Subject: April 2010 Inspection Report, Cameco Resources, Permits 603 and 633

**APRIL 2010 INSPECTION REPORT
DISTRICT 1/LAND QUALITY DIVISION**

COMPANY: Cameco Resources (CR), Highland Ranch, Permit #603
& Smith Ranch, Permit 633

Figure 1b Storage tanks at Highland Processing Plant

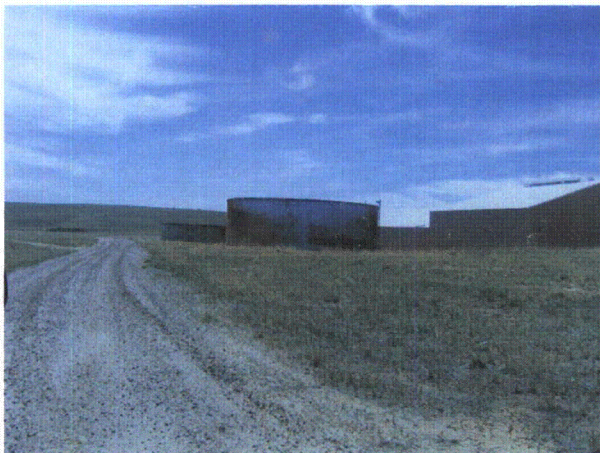
HUP Processing Plant and Offices - The facilities are abandoned, however, the office building is currently being used to house historic records for the mine. The processing plant was historically used for the open pit mine and at a later date for insitu mining. It was confirmed by CR that it has not been decontaminated. Used tanks and other old equipment are being stored on the east side of the plant including tanks that were used for ammonia, nitrogen, raffinate (product recovery solution), and reverse osmosis (**Figure 1**). The area is fenced with a locked gate at the entrance leading to the gravel parking area and facilities. It is apparent the facilities have been neglected for a long period of time and would require substantial structural inspection and most likely considerable renovation if they are to be used again. **Of greater concern is the need to decontaminate the tanks and processing plant. CR must submit a proposal to reclaim the processing plant and offices.**

- 1 The LQD formally requested a plan to reclaim the HUP Processing Facilities through the 2008-2009 Annual Report Review. A deadline for the plan submittal was set for June 1, 2010. CR requested through a letter dated May 25, 2010, an extension until September 30, 2010 to submit the reclamation proposal. LQD grants this request and will expect a comprehensive proposal to address the entire facility. If CR intends to use the facility in the future a proposal for renovation will be required for LQD review and concurrence prior to re-opening the facility. CR also requests a meeting to discuss the proposal. Please contact the permit coordinator to schedule the meeting

Figure 2 Radium Ponds

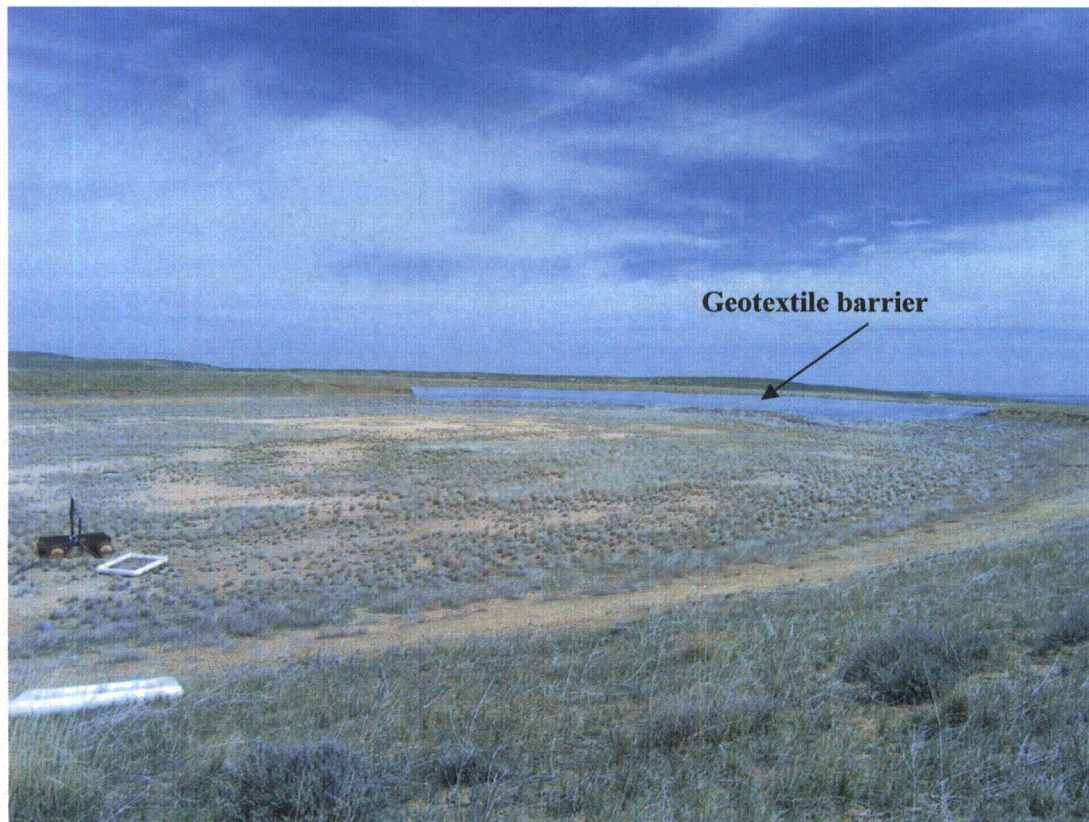
Radium Ponds – The ponds were observed and it was noted that one pond had a small pool of water in the bottom collected during recent precipitation; the other was dry (**Figure 2**); both ponds were well vegetated. No reclamation work has begun. CR is in the process of training new staff to operate the new spot scanner so that on-site sampling can be completed as excavation occurs. **CR must develop and submit a proposal to reclaim the ponds for LQD review prior to beginning reclamation.**

- 2 Radium pond reclamation was also addressed in the May 25, 2010 letter to LQD. The letter states a schedule for the reclamation will be sent to LQD by July 30, 2010. NOTE: LQD requests a reclamation proposal for the selenium pond addressing the volume of contaminated material to be excavated, disposal plans for the material, proposal for re-grading the topography, replacement of contaminated soils (source and volume) and a seeding schedule. This proposal will need to be reviewed and approved prior to initiating reclamation of the ponds so that LQD can provide concurrence with a future request to remove the pond reclamation from liability in the surety.

Figure 3 View of PSR-1, dry. limited vegetation

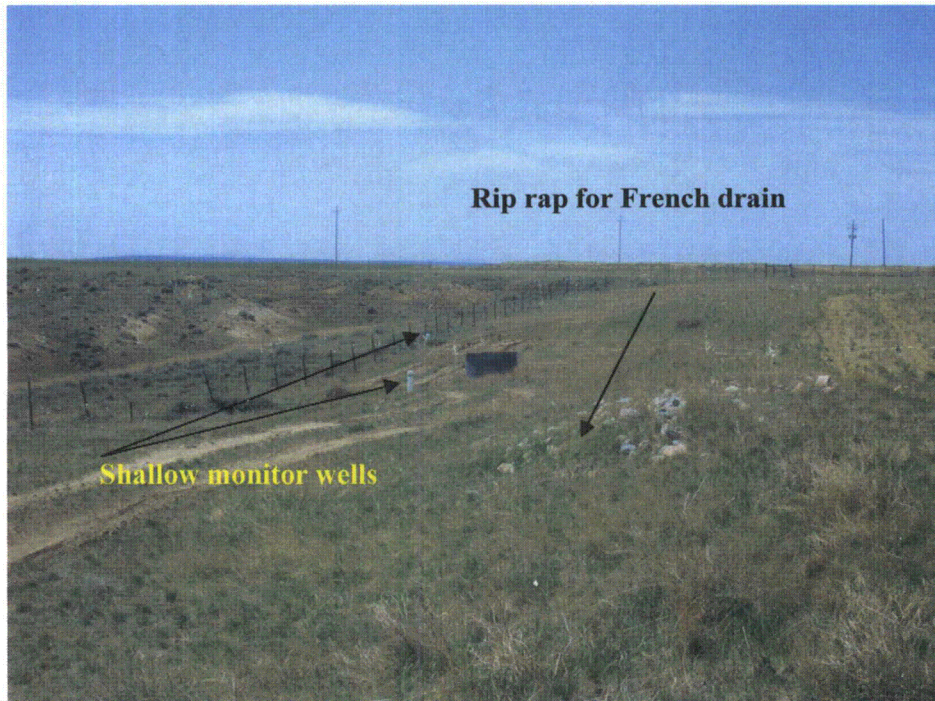
PSR-1 and Irrigator 1 – The pond was dry with limited vegetation. No erosion was observed on the side slopes of the pond. A French drain was installed to mitigate a leak at some time during the use of the pond. The geotextile is still secured to the slope (**Figure 3**). It was installed to help control the leak. Several shallow wells are located down gradient of the leak (**Figure 4**). The irrigator was observed from a distance on the irrigation site and was not in use.

- 3 PSR-1 Irrigator and Pond. These facilities also require a formal proposal for reclamation and should be addressed in the HUP Facilities proposal. If CR intends to use the irrigator or pond in the future a proposal for renovation will be required for LQD review. Please ensure the shallow wells are included in the surety estimate for the 2010-2011 Annual Report.
